**September 26, 2025
Addendum #2
FOR IMMEDIATE ATTENTION**

Reference – Invitation for Bid:	IFB #003-0-2026/SB
For Delivery To:	Menchville High School HVAC System Replacement
Bids Due:	Newport News Public Schools October 7, 2025 at 2:00 PM EST

ADDENDUM NO. 2

**HVAC Replacement
Menchville High School
Bid # 003-0-2026/SB
Newport News, Virginia
TCE #23-065**

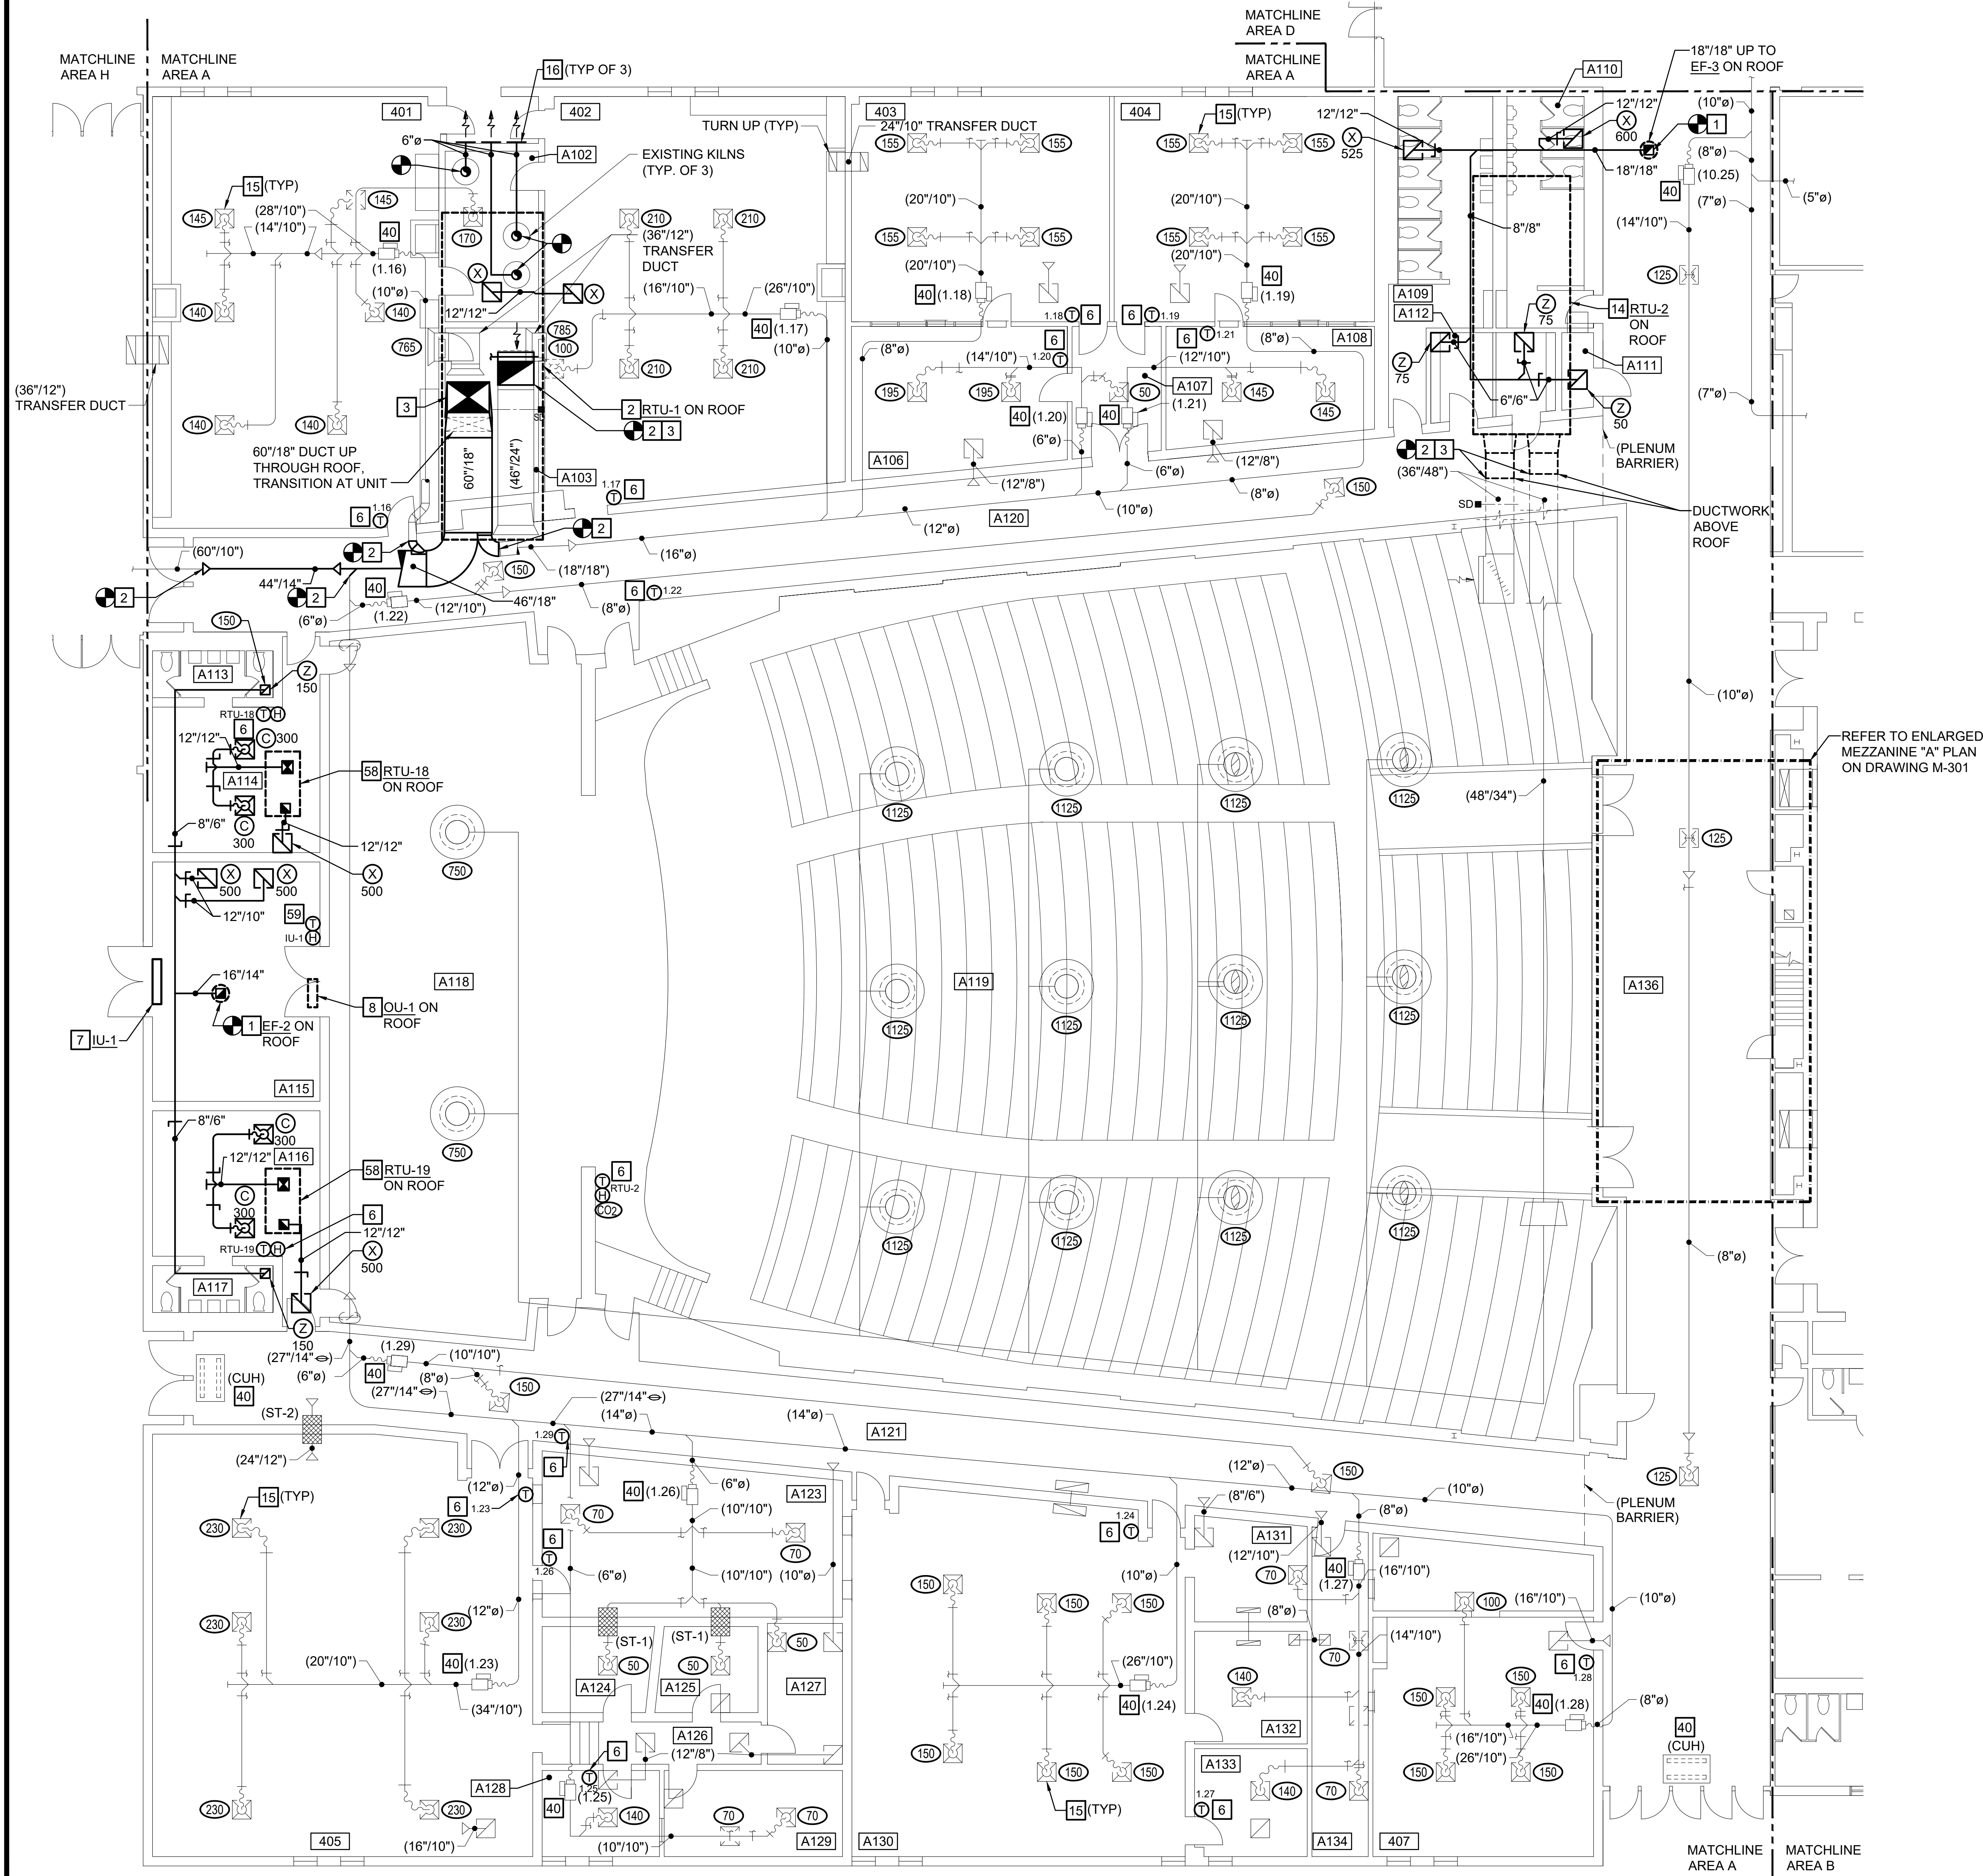
Sheet M-101 through M-110:

- Construction Notes: REVISE keynote 40 to the following: PROVIDE NEW HONEYWELL "OPTIMIZER T1L" CONTROLLER COMPATIBLE**

WITH BUILDING AUTOMATION SYSTEM AND CONTROL VALVE ON ALL LEGACY CONTROLLERS. REFER TO CONTROL DRAWING FOR FURTHER INFORMATION.

40	PROVIDE NEW HONEYWELL "OPTIMIZER T1L" CONTROLLER COMPATIBLE WITH BUILDING AUTOMATION SYSTEM AND CONTROL VALVE ON ALL LEGACY CONTROLLERS. REFER TO CONTROL DRAWING FOR FURTHER INFORMATION.
58	REFER TO "ADAPTER CURB DETAIL" ON DRAWING M-402.
59	PROVIDE NEW WALL MOUNTED THERMOSTAT AND CONTROL WIRING.
